**Car Stereo
Service Bulletin**

Model: XE-90MKII

No. 189

Subject: IC101/PC Board Compatibility
Problem

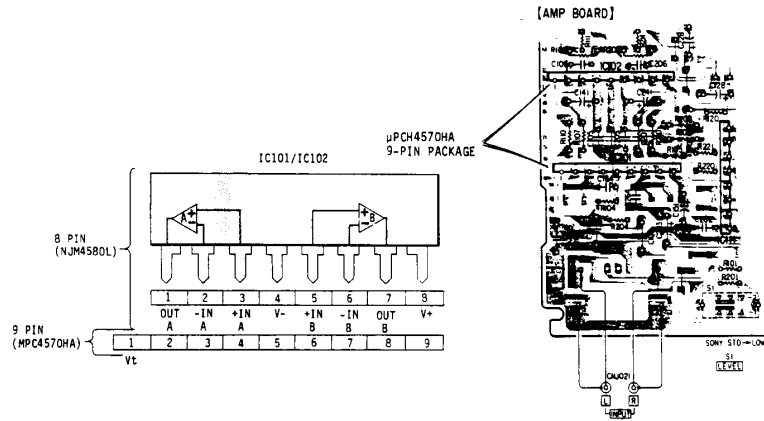
Symptom:
(53)

Audio distorted.

Solution: If this symptom occurs, please perform the following procedure:

Replace IC101 and/or IC102 with Part Number 8-759-710-73 (NJM4580L). This is an 8-pin in-line package which will fit the PC Board without modification.

If this part is not available, then order Part Number 8-759-112-93 (uPC4570HA). This is a 9-pin in-line package which may be used if Pin 1 is removed and the IC is inserted so that Pin 2 is located in the PC Board Pin 1 position.
